RE: Review Comments
Tierra Linda Apartments
Albuquerque, NM
Plan Check No. PR-2021-005630
Project No. 24-2031-01

Below, please find our responses to your comments dated 12/11/24:

DFT Resubmittal

A1.1

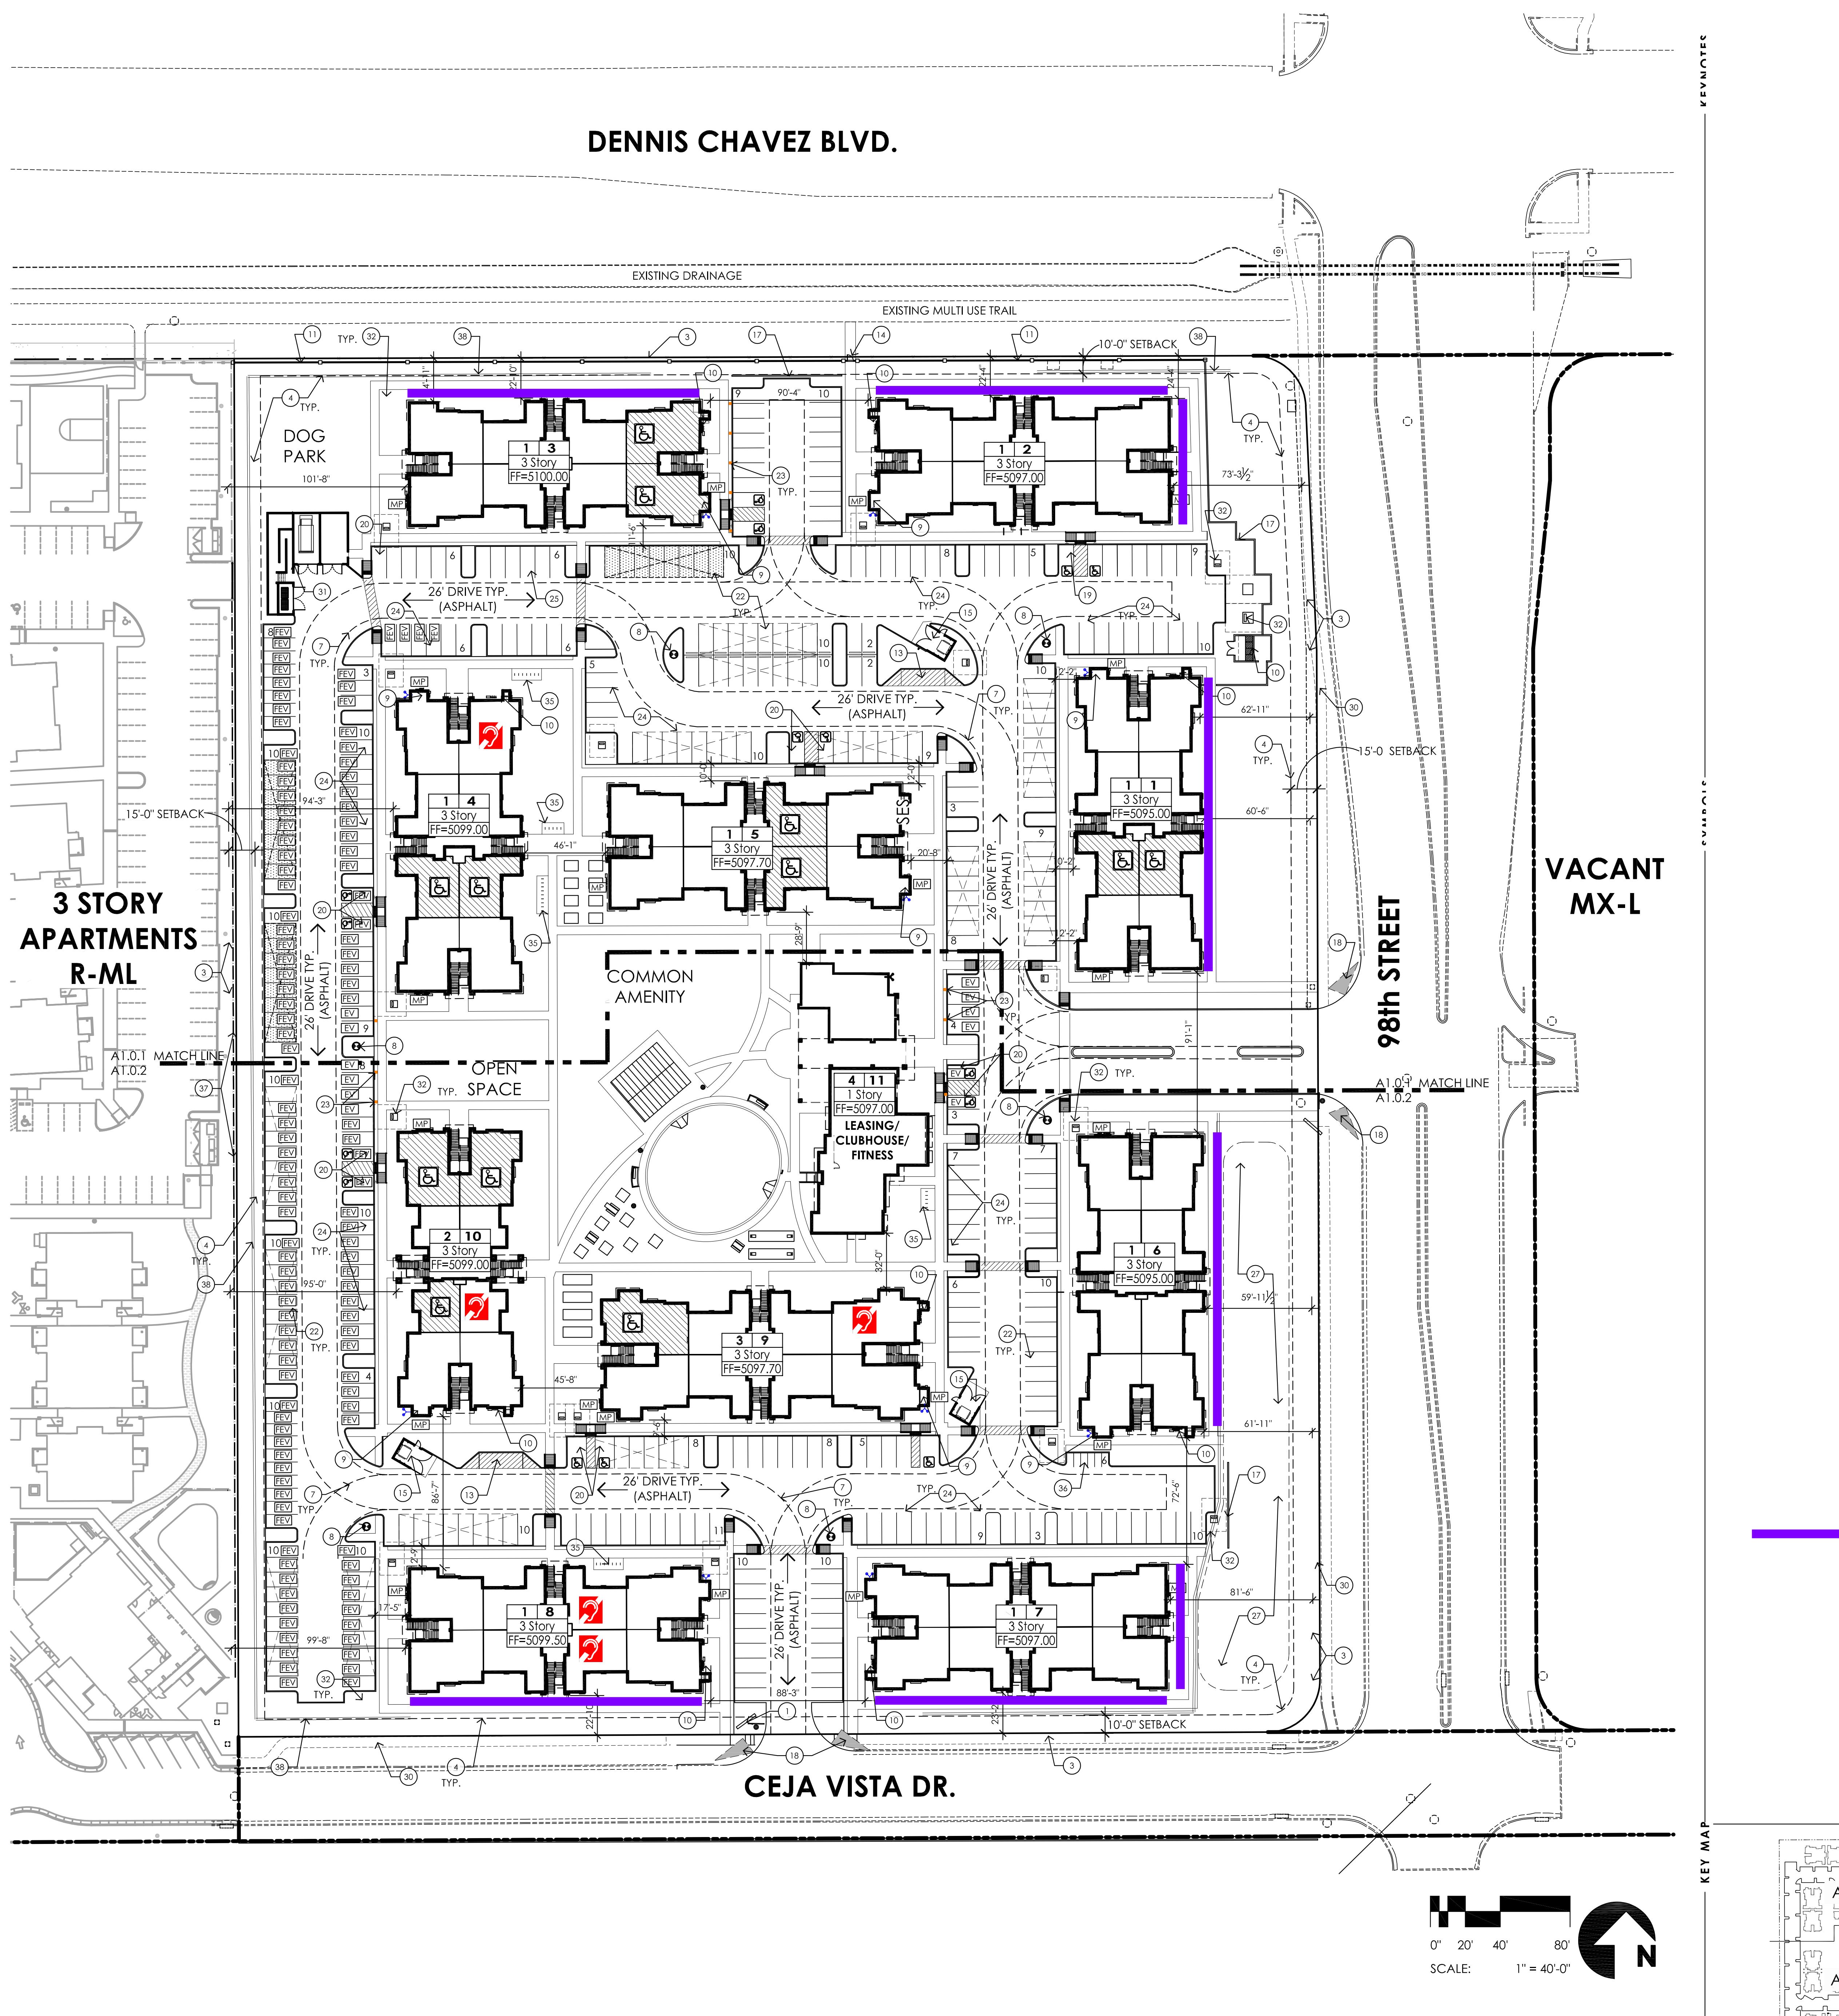
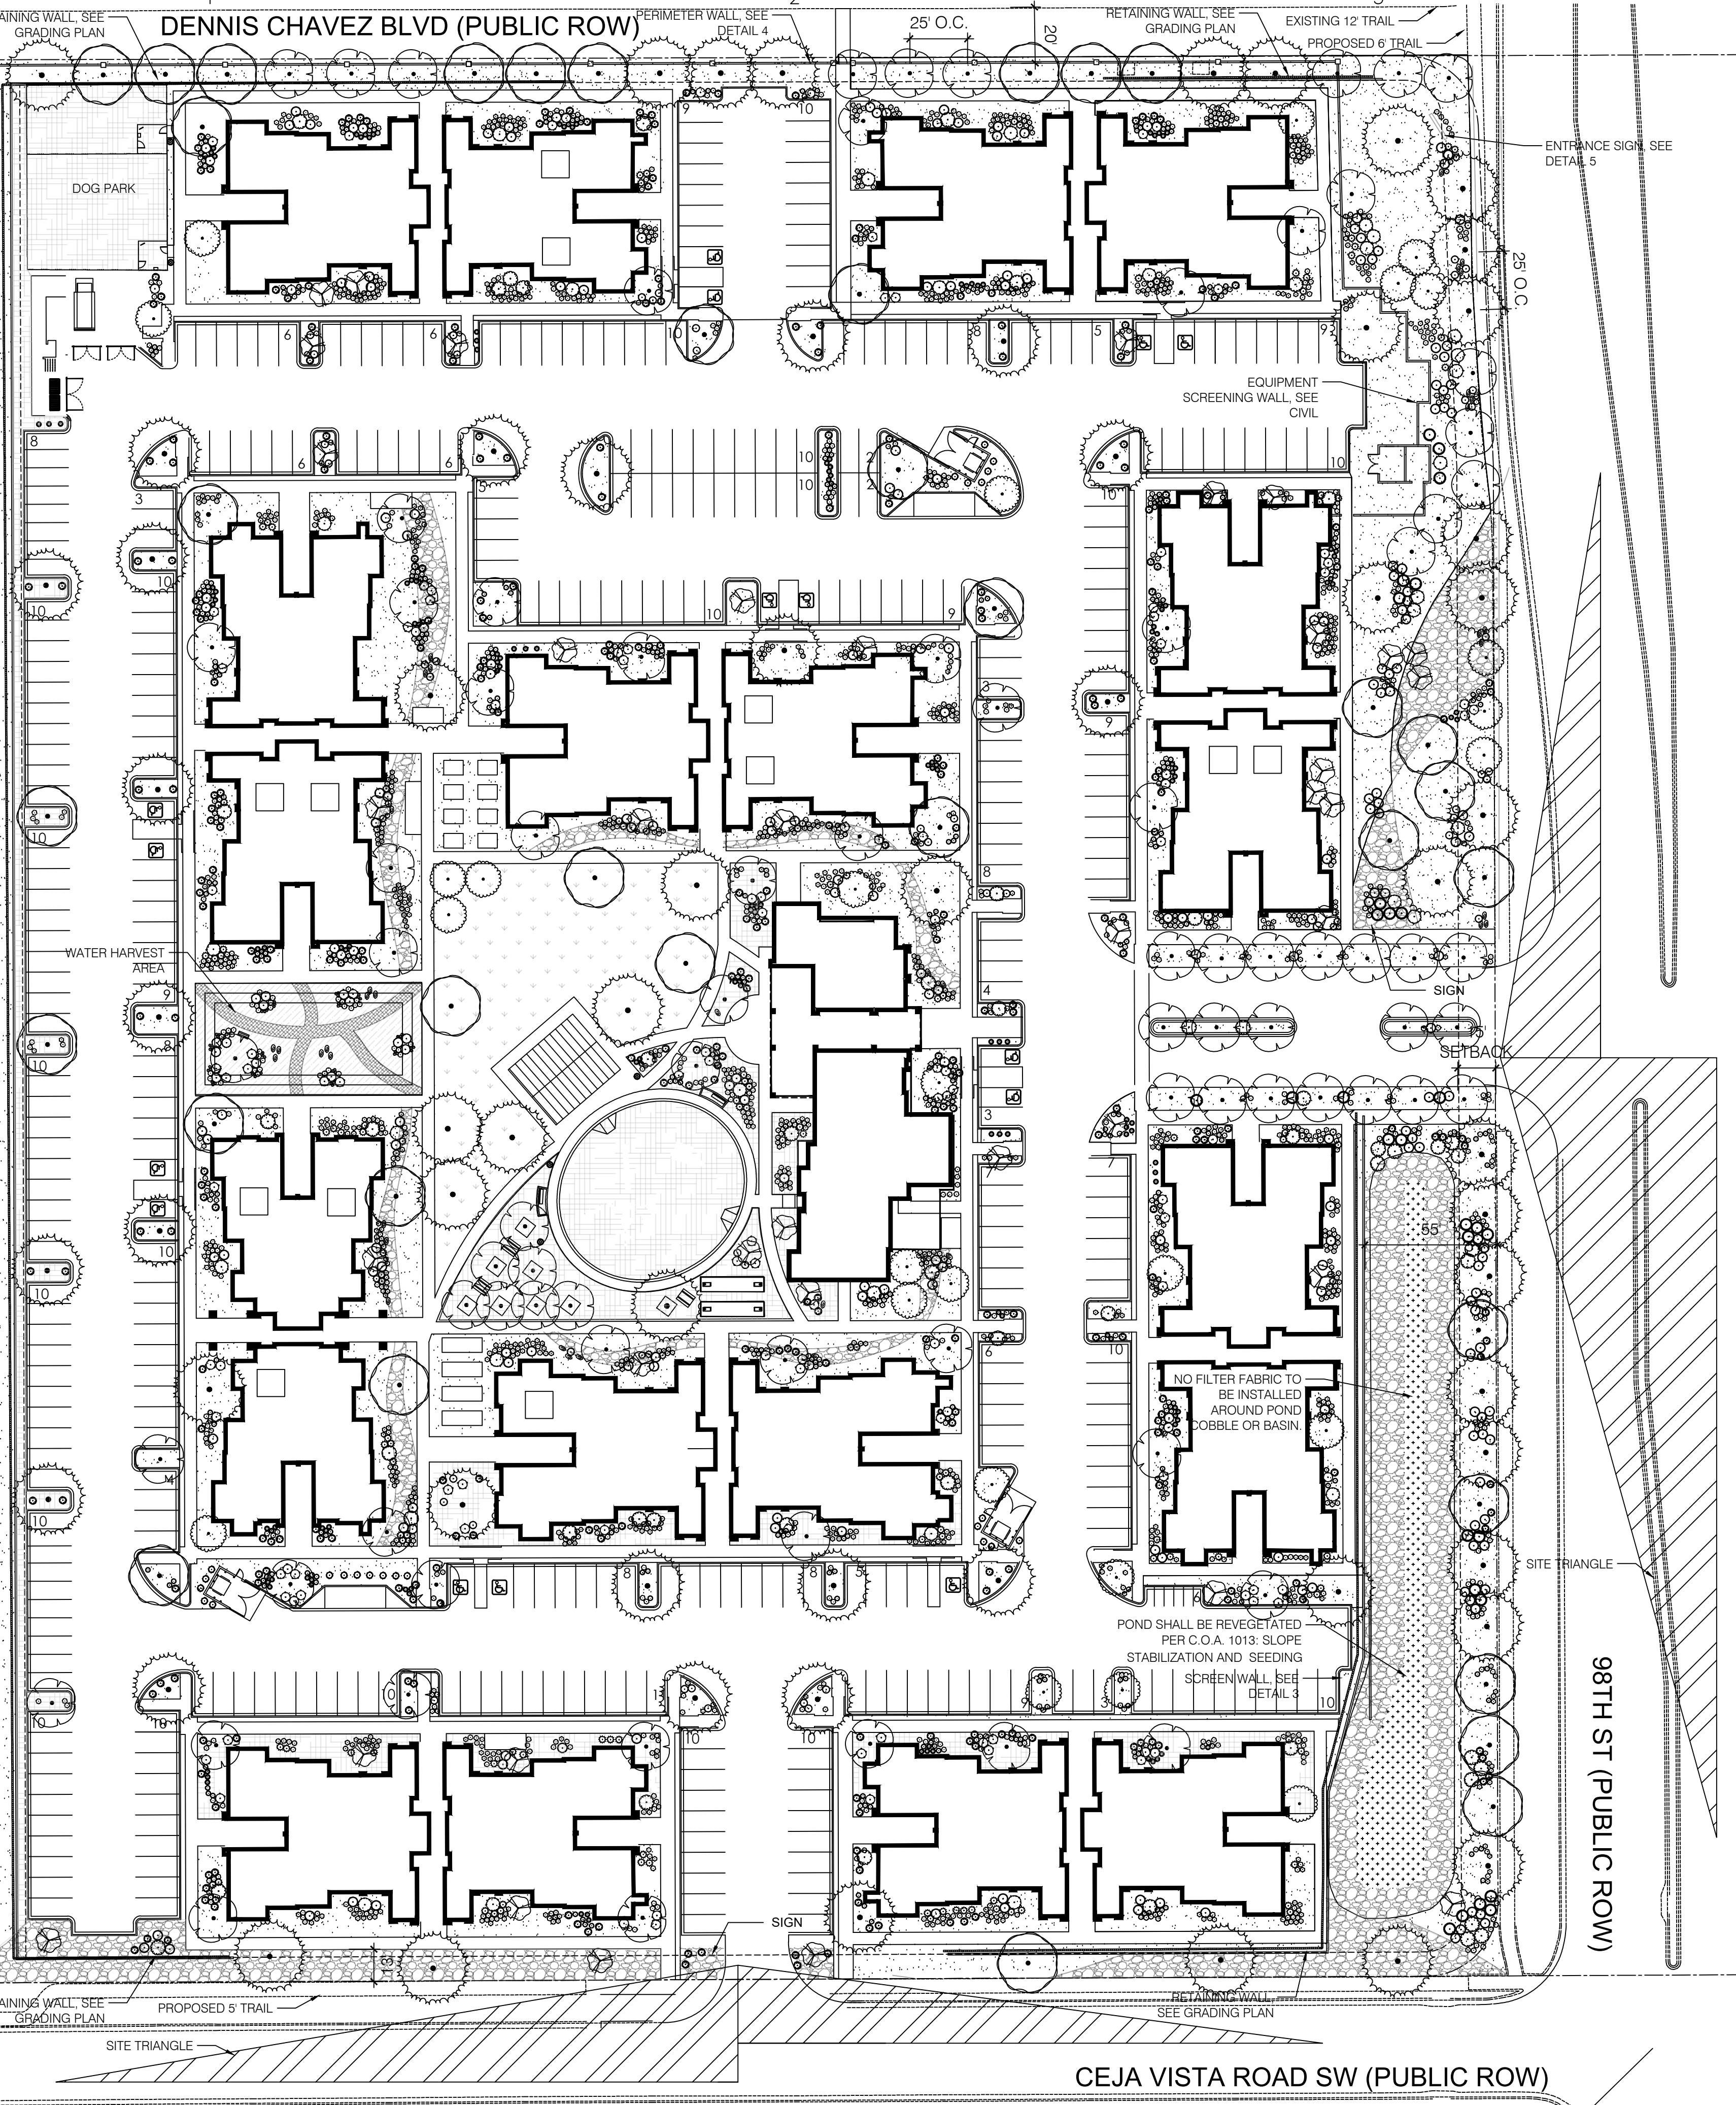
1. Planning calculations do not reflect the required parking for the Clubhouse as a Residential Community Amenity. Need to revise to include Part 14-16-5: Development Standards, 5-5: Parking and Loading.

- ***Parking spaces for the Residential Community Amenity (Clubhouse/Leasing), have been included in the parking calculations.***
2. Parking calculations are well done for the apartments, but do not reflect the required five percent of off street parking spaces that are required to have EV charging stations (20 spaces), as per IDO 5-5(C)(9)(c).

3. Please note that there are parking credits gained for each EV charging station parking space, which will assist in covering spaces needed for the clubhouse , as noted in comment #1.

- ***Parking calculations now include 12 EV Charging Stations and 102 EV Capable parking spaces. These spaces are called out on the site plan as EV and FEV.***

- ***An additional 12 parking spaces have been added to the total parking count for the EV parking credit.***
